# Plan Commission

### Agenda

| Monday, January 23, 2017 | 7:00 PM | De Pere City Hall Council Chambers |

**SUBJECT:** Recommendation regarding a Revised Site Plan request at 1212 N. Enterprise Drive in De Pere for a warehouse addition and parking lot expansion (Parcels ED-2070 and ED-2069). Applicant: Mach IV Engineering & Surveying LLC

SHEET:  
C3.0

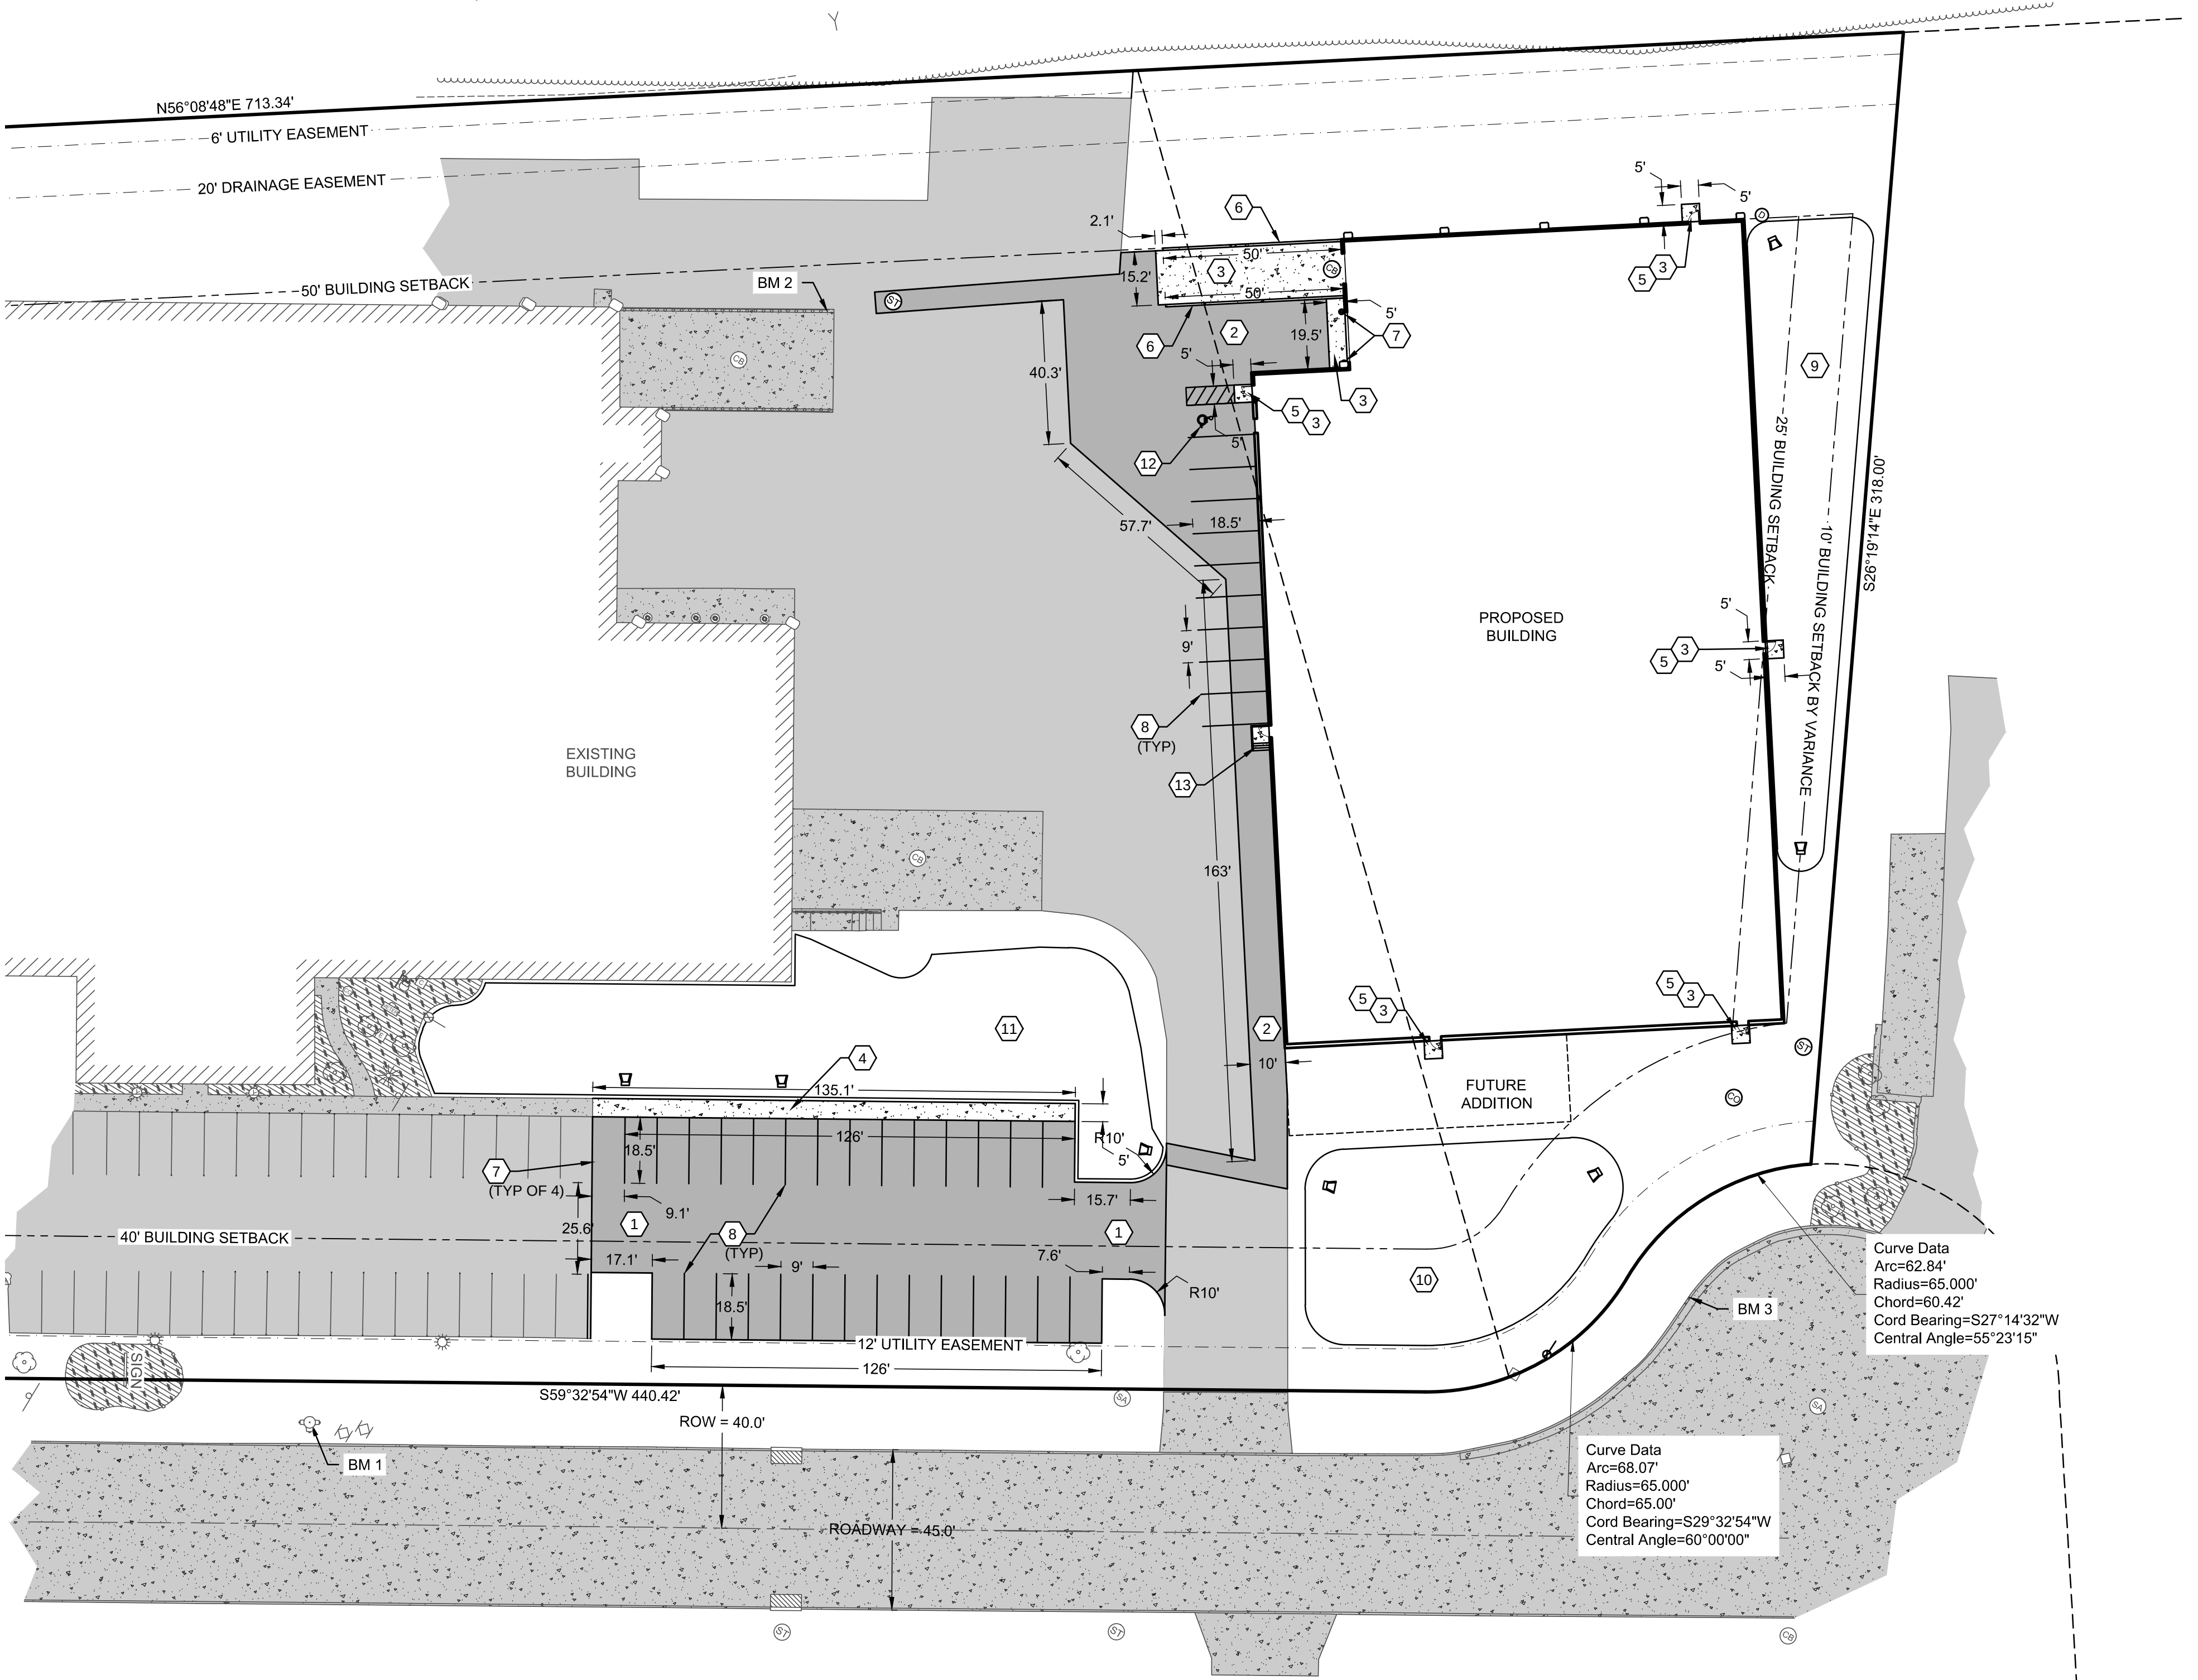
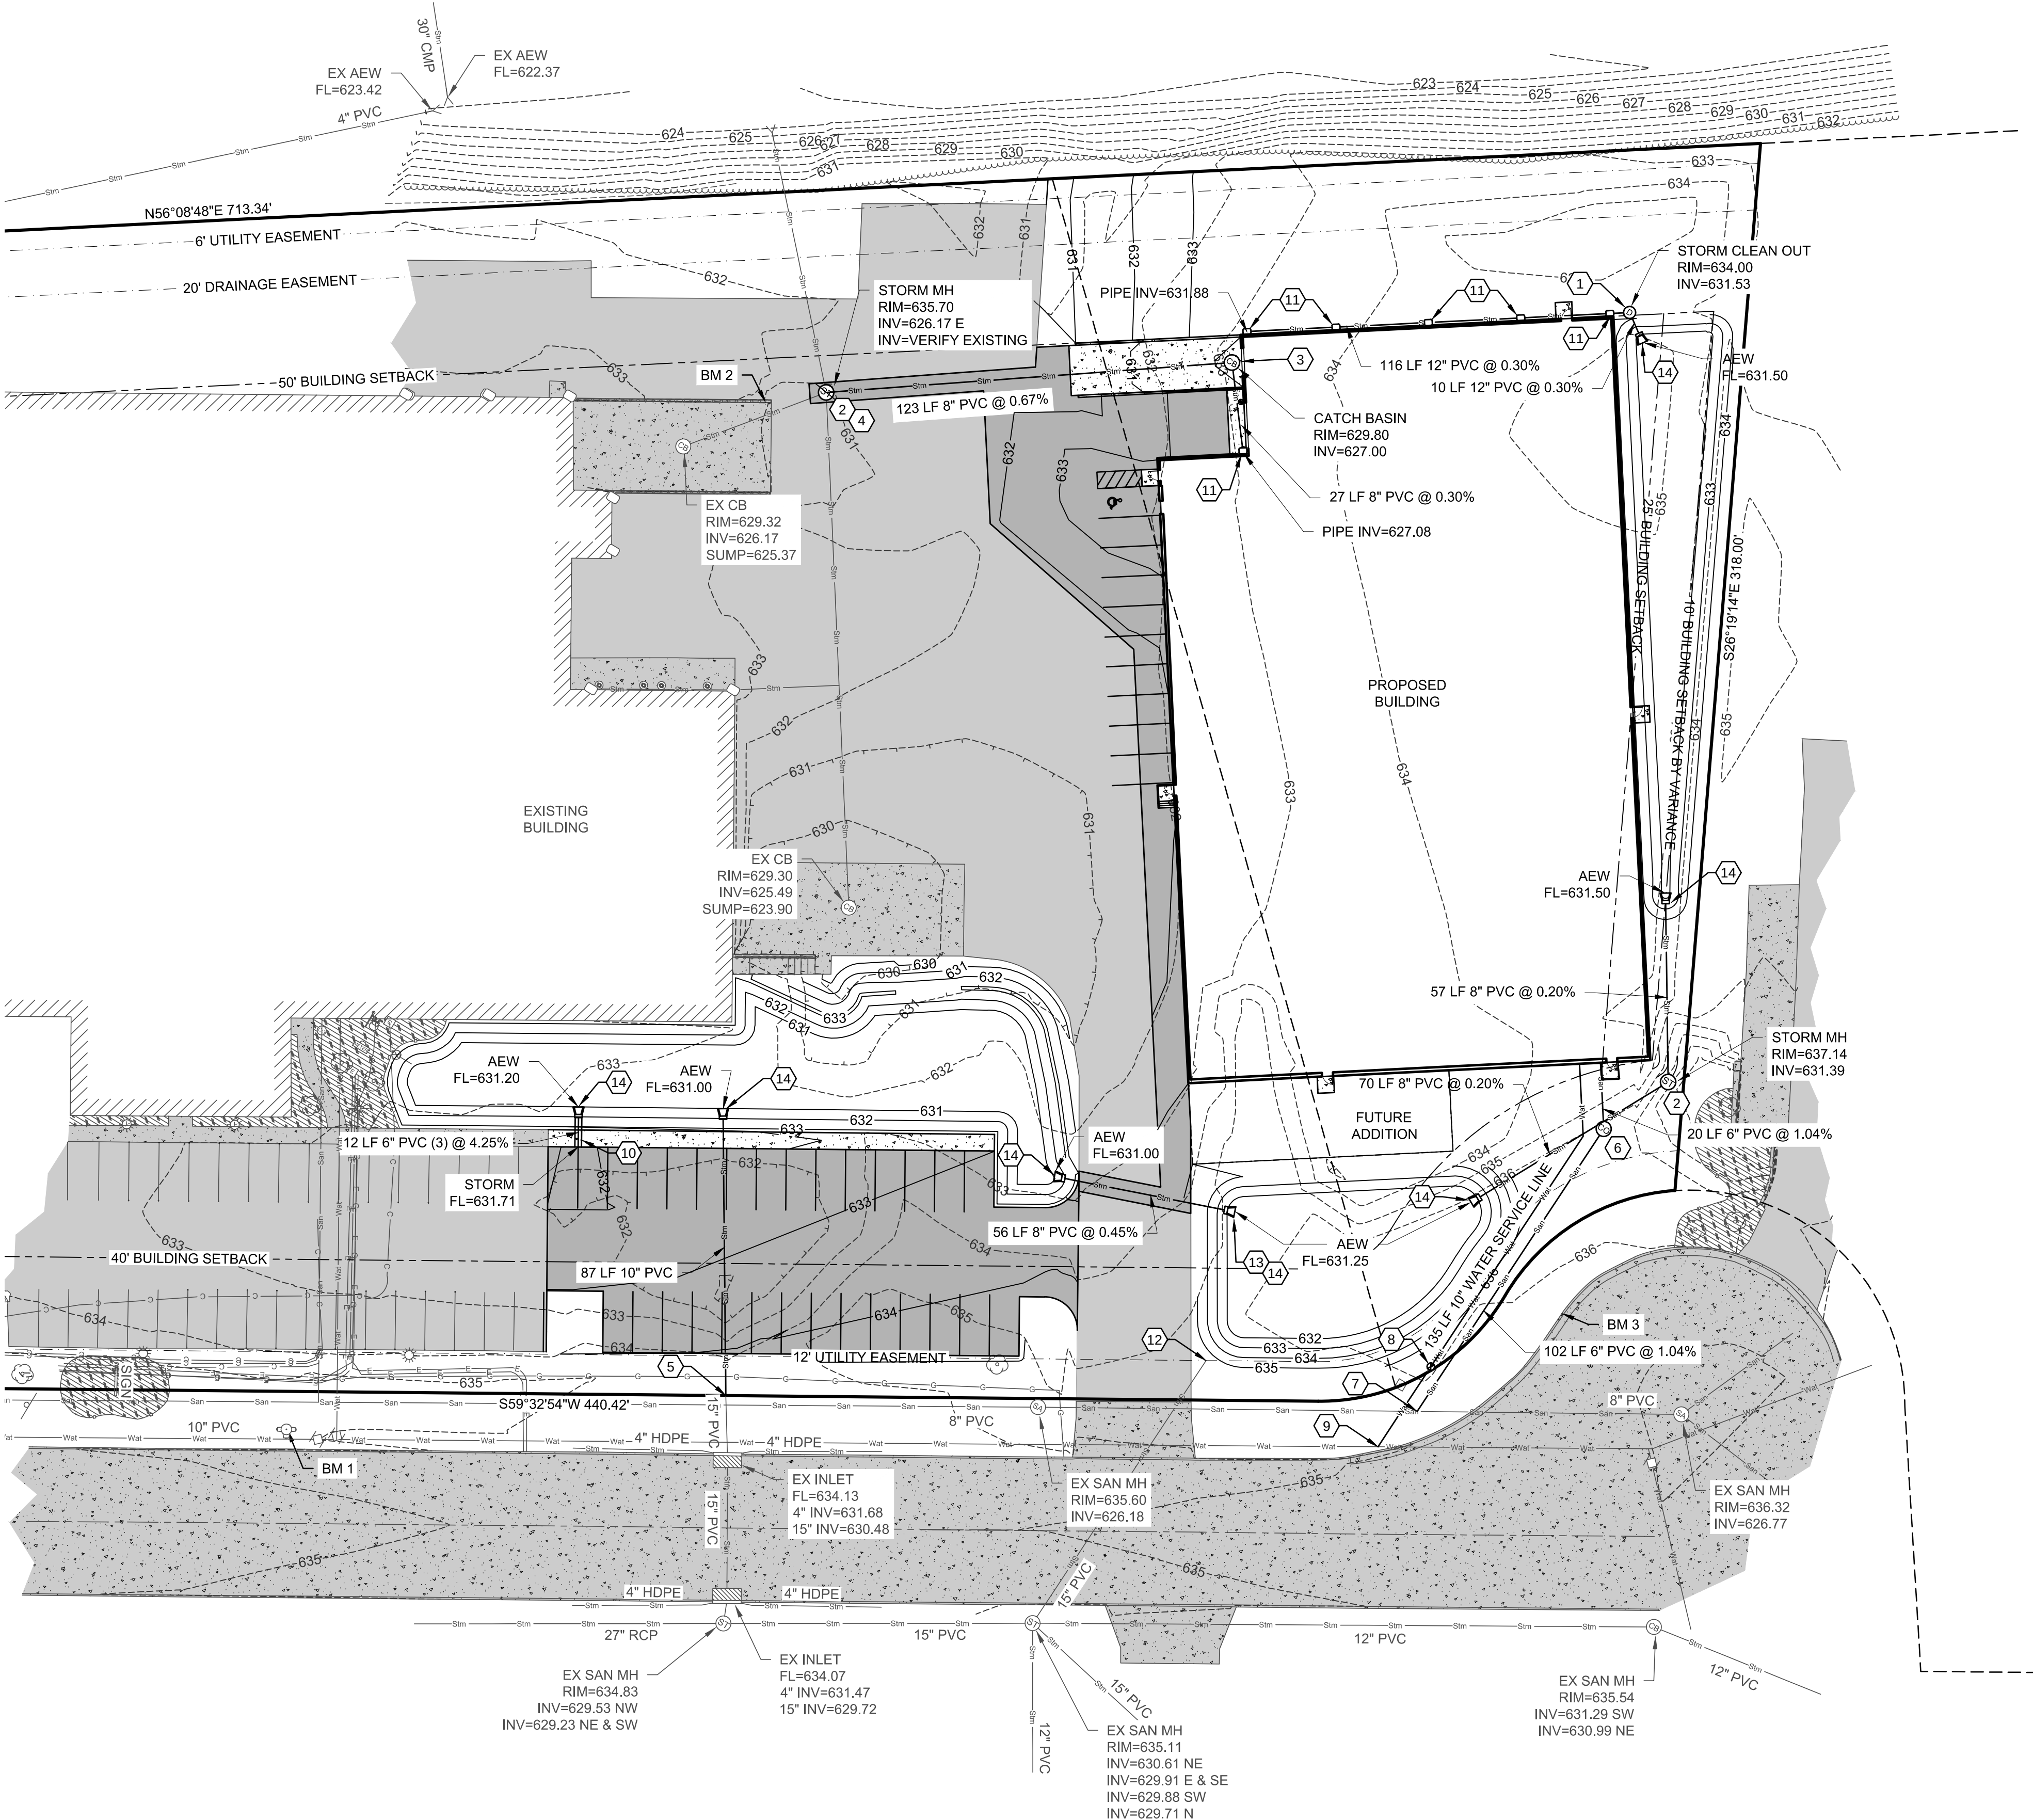
3. On the Utility Plan C3.0 need to have a comment to acquire an excavation permit with City of De Pere Public Works at 925 S. Sixth Street prior to excavating in the right-of-way and connecting the water service and sanitary service. Call Public Works at 920-339-4061. Added. See Sheet C3.0

4. On the Utility Plan C3.0 need to have a comment to contact the City of De Pere Water Department prior to connecting water service to the water main. They will need to be present at the time of connection. Call Water Department at 920-339-4063. Added. See Sheet C3.0

5. Need to provide the water service size for the proposed building. If the water service is four-inches in diameter or greater, additional testing will be required (i.e. pressure, safe sample). Added. See Sheet C3.0. Additional testing will be submitted.

6. Water meter size (If greater than a 1", one month advance notice required so Water Department can order the meter). Added. See Sheet C3.0. Consider this submittal as notice of need of meter.

10. On the Utility Plan Sheet C3.0 show the old storm sewer lateral as capped like shown on the Existing Conditions Sheet C1.0 - comment 6. Added. See Sheet C3.0

11. On the Utility Plan Sheet C3.0, all PVC storm pipes need to have secured concrete end walls. Apron End Walls added. See Sheet C3.0
12. Update sheet key notes for the details on the Site Plan sheet C2.0. Updated.
